PLANNING AND URBAN DESIGN

27 January 2024

**RE: Zoning for Midtown Apartment Neighbourhoods  
Draft Zoning By-law Amendment  
207, 209, 213, 225 Davisville Avenue & 224, 226, 228, 236,  
240 Balliol Street – Site-Specific Comment Submission  
Item 2024 - PH9.1  
WND File: 23.597**

Figure 3: Subject Site in context of proposed By-law height overlay.

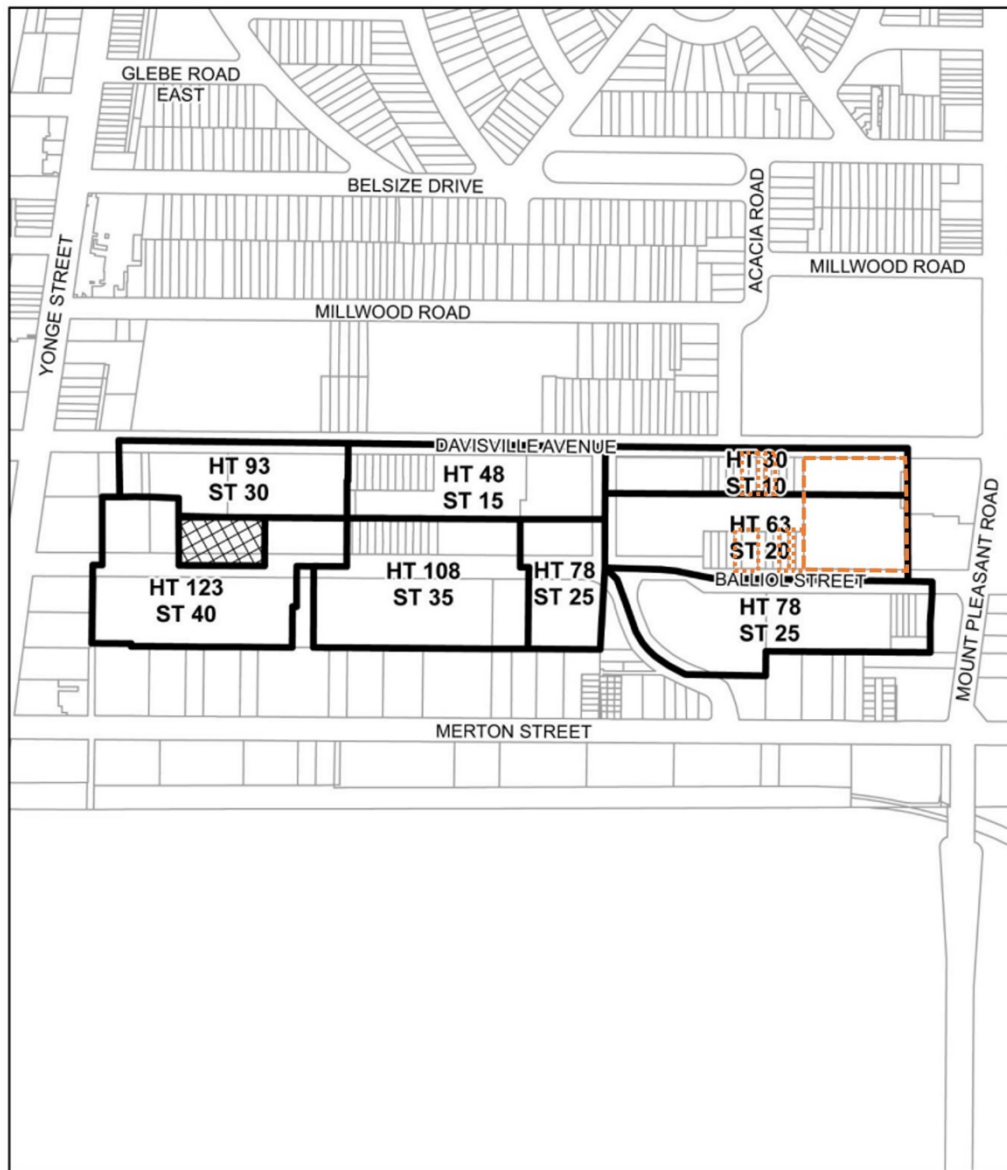
Map 4D of the Draft By-law proposes to introduce new maximum height permissions. The Subject Site is within an area where the permitted height is a maximum 10 storeys (30 metres) for its northern portion, and 20 storeys (63 metres) for its southern portion.

Although it is generally positive that the south portion of the Subject Site is being recognized as having potential for a tower, the proposed heights do not align with the Secondary Plan's anticipated height range for the *Davisville* Character Area, and generally speaking, is also inconsistent with the Secondary Plan policies that contemplate a transition of buildings heights down as distance increases from Davisville Station (with no such policy regulating heights from north to south). The anticipated height range for the *Davisville* Character Area (Policy 5.4.3.h) is 40 to 25 storeys with heights transitioning down as distance increases from Davisville Station. The Subject Site is located at the eastern boundary of the area for which this policy applies to. As such, at a minimum, the maximum permitted height for the Subject Site should be revised to 25 storeys (78 metres) across the entirety of the property to be consistent with the Secondary Plan.

4. Revise height Diagram 4D to reflect permissions for, at a minimum, 25 storeys (78 metres) across the entirety of the Subject Site to reflect its proximity to the Davisville subway station, and to be consistent with the lower end of the height range provided by Policy 5.4.3.h of the Secondary Plan;
-

Figure 4: Zoning By-law Diagram for 185 Balliol St & 8 Pailton Cres

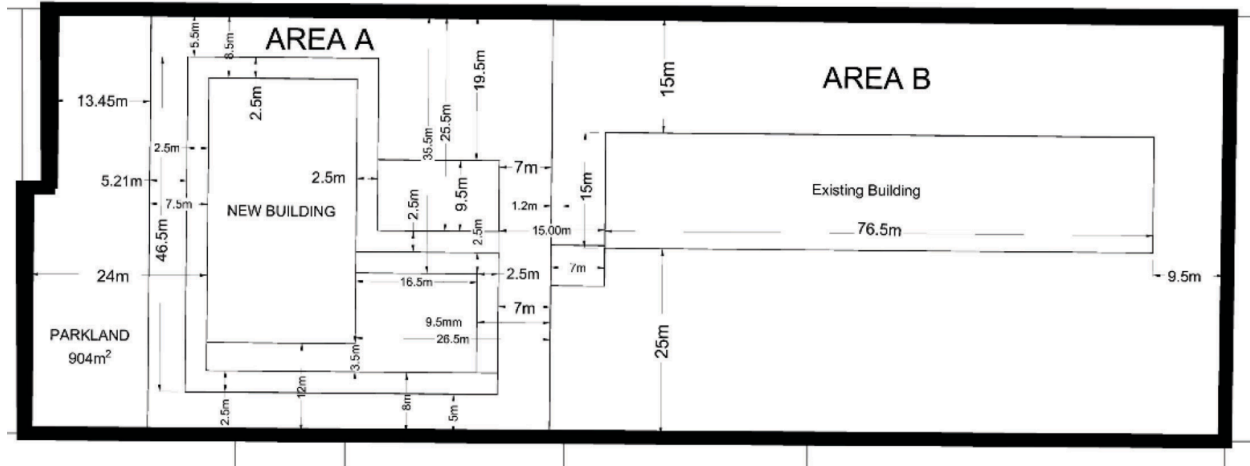
There are three recently-approved Zoning By-law Amendment applications within the *Davisville* Character Area which provide permissions for minimum street yard setbacks below 6.0 metres, with the lowest value being 5.5 metres. These examples also provide a minimum rear yard setback distance of 5.0 metres, and their approved zoning by-law diagrams with minimum yard setbacks are found within **Figures 4 to 6** below. When taking the Draft By-law's proposed street and rear yard setbacks together, along with the proposed tower setbacks from the podium, tower separation distances, and tower setbacks from the side property lines, the Subject Site's potential to accommodate meaningful redevelopment would be severely impacted.

1. Revise the minimum street yard and rear yard setbacks to align with the minimum distances within the recently approved examples feature in **Figures 4 to 6**. In this case, the minimum street yard setback distance for lots abutting Keewatin Avenue, Davisville Avenue, Balliol Street, Soudan Avenue, Holly Street, Dunfield Avenue, Lillian Street, Redpath Avenue, and Brownlow Avenue would be 5.5 metres, while the minimum rear yard setback distance would be 5.0 metres;
